Re: Docket No. 370 - CT Greater Springfield Reliability Project

Response to CSC-02 Interrogatories dated 04/02/2009 CSC-027, 028, 029, 030, 031, 032, 033, 034, 035, 036, 037, 038, 039, 040, 041, 042, 043, 044, 045, 046, 047, 048, 049*, 050, 051

$\frac{\text{Response to OCC-01 Interrogatories dated }04/02/2009}{\text{OCC-001, }002, \,003, \,004, \,005, \,006, \,007, \,008, \,009, \,010, \,011, \,012, \,013, \,014}$

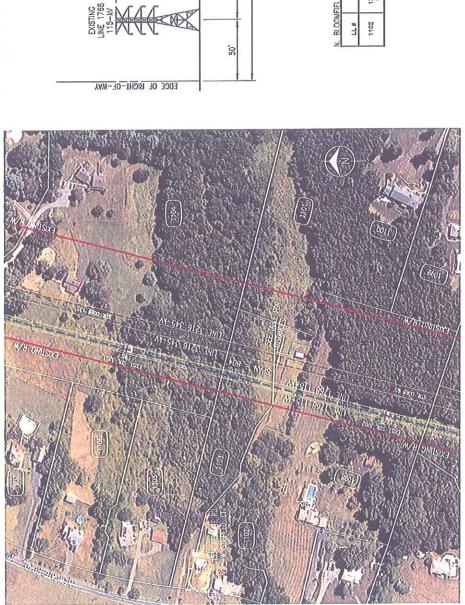
Two building structures are within the existing CL&P transmission line easement, as represented on Mapsheet 28 of 45. Both of these building structures are barns and are represented on the attached drawings (CSC-LL 1102 and CSC-LL -1104). The transmission line design represented on these drawings is the delta configuration, as presented in Volume 10, XS-2 BMP. As noted on drawing CSC-LL 1102, the estimated horizontal distance from the center of the proposed transmission line to the nearest edge of the barn is 17 feet, and 2.4 feet horizontal from the nearest conductor to the nearest edge of the barn (based on aerial survey information). As noted on drawing CSC-LL 1104, the estimated horizontal distance from the center of the proposed transmission line to the nearest edge of the barn is 35 feet, and 20 feet horizontal from the nearest conductor to the nearest edge of the barn (based on aerial survey information). Preliminary engineering indicates that these structures cannot remain in the ROW and must be removed prior to start of construction, due to electrical safety clearance requirements. CL&P will work with the property owner(s) to remove/relocate the structures from the ROW.

Figure O-10: Profile XS-2 UG: 4.6-mile/3.6-mile UG line variations within ROW to Phelps Road transition station – Magnetic fields under pre-NEEWS (2012) and post-NEEWS (2017) conditions at AAL¹

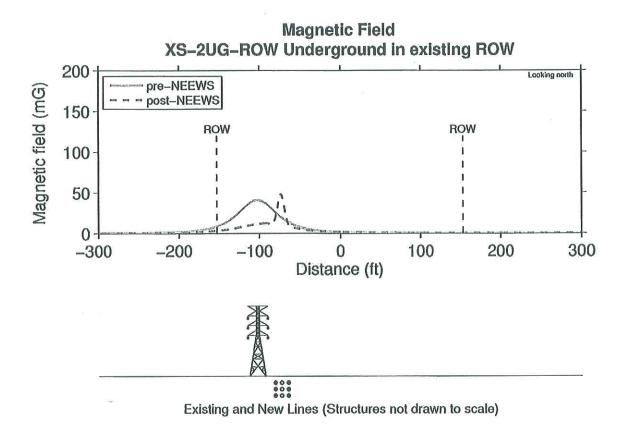
- 1. On page O-15 in section O, the dispatch Table O-2 contains several errors. In the APL Pre-NEEWS column, the CT E-W transfer level should be 2,500 MW, in both of the AAL columns, pre and post NEEWS, the figure for West Springfield unit #3 should be 0 MW, and a row is missing for Cobble Mountain which was dispatched at 17 MW in all columns.
- 2. In section O, Figure O-10 and Table O-7 omitted pre-NEEWS information for ease of comparison. Replacements for Figure O-10 and Table O-7 are attached.
- 3. The overhead line's life-cycle cost figure of \$84,900,000 in Table I-4 should be \$85,070,105, matching the figure on page 1 of Appendix H-1.

Figure 1: Light (30%) GSRP2, Agawam-Ludlow Out, Fault @ N Bloom

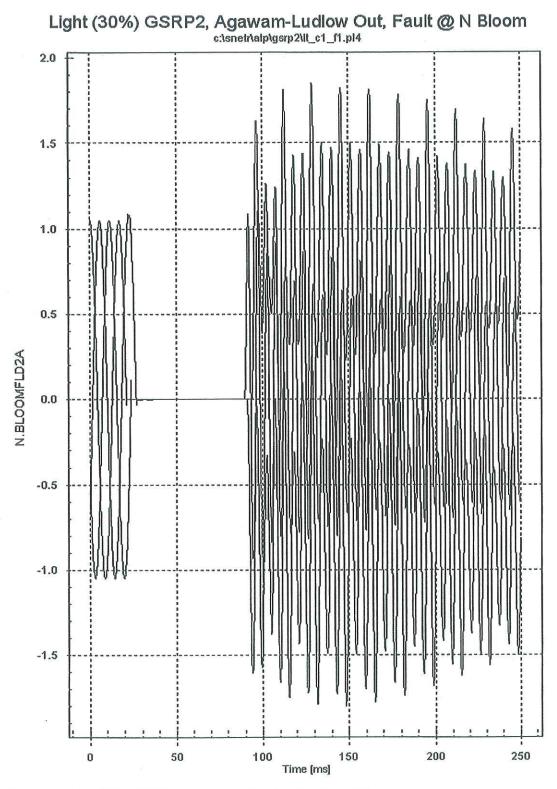
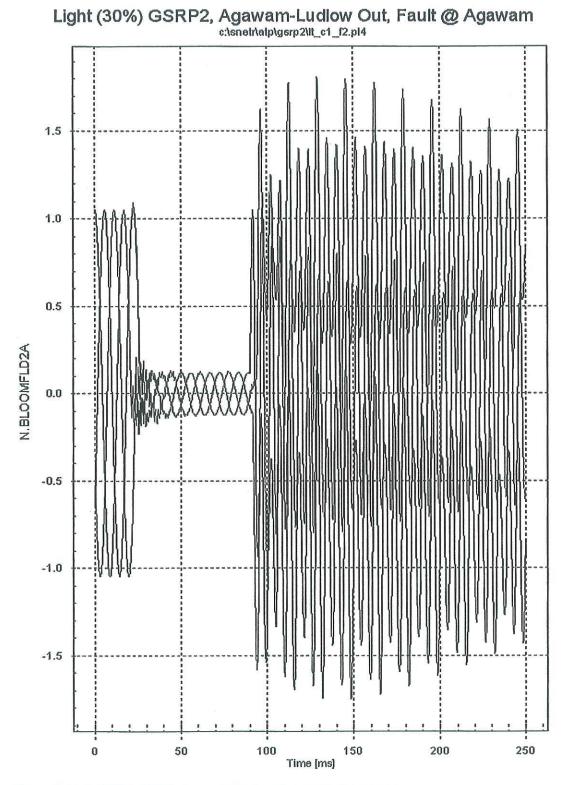
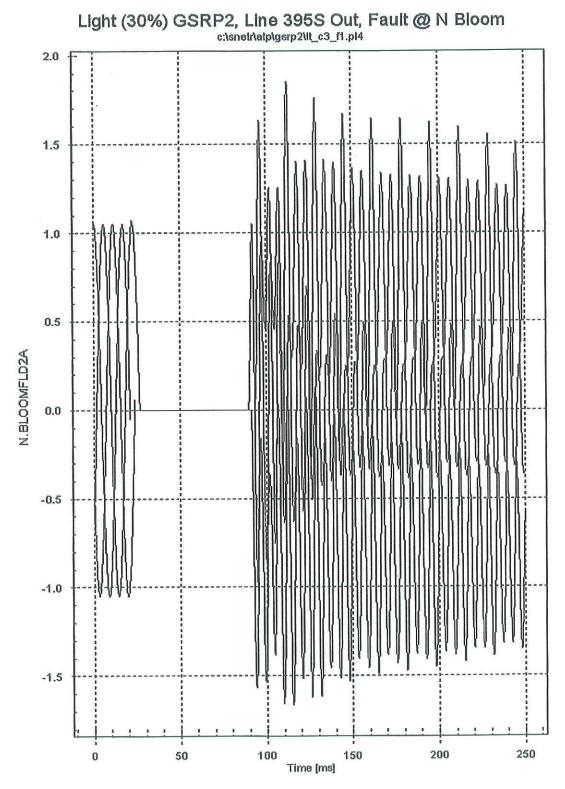
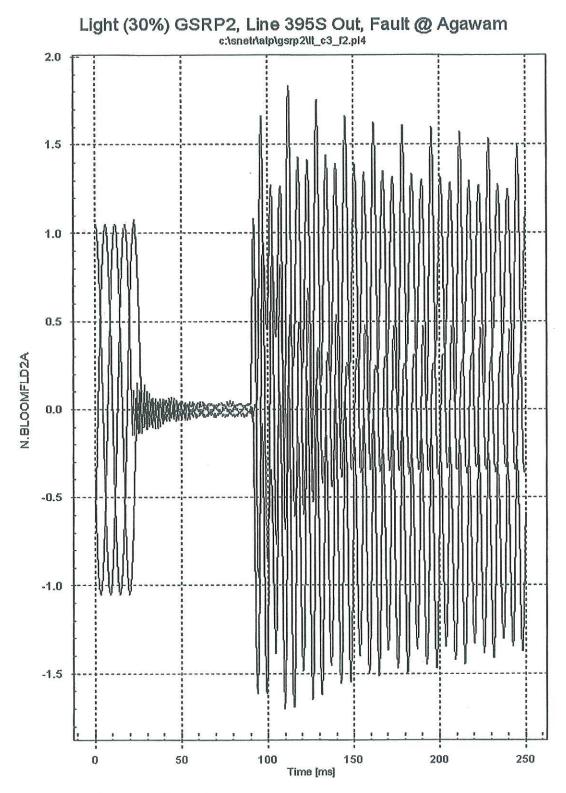
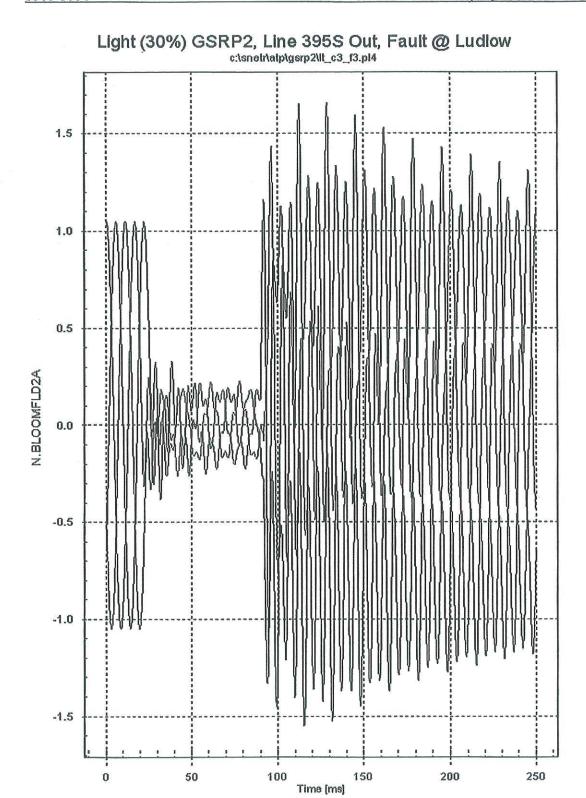
(b) Has CL&P performed any studies of whether either or both of these all-underground route variations would have an adverse effect on electric system reliability? If so, please provide copies of any such studies.

Please note that the term "tehnically feasible" used in the interrogatory and in this response is not the opposite of the term "technologically infeasible" in Conn. Gen. Stats. sec. 16-50p(i) (the "underground presumption" provision) since the latter term incorporates concepts of comparative reliability of overhead and underground lines and unreasonable burdens on ratepayers from the excess cost of underground construction.
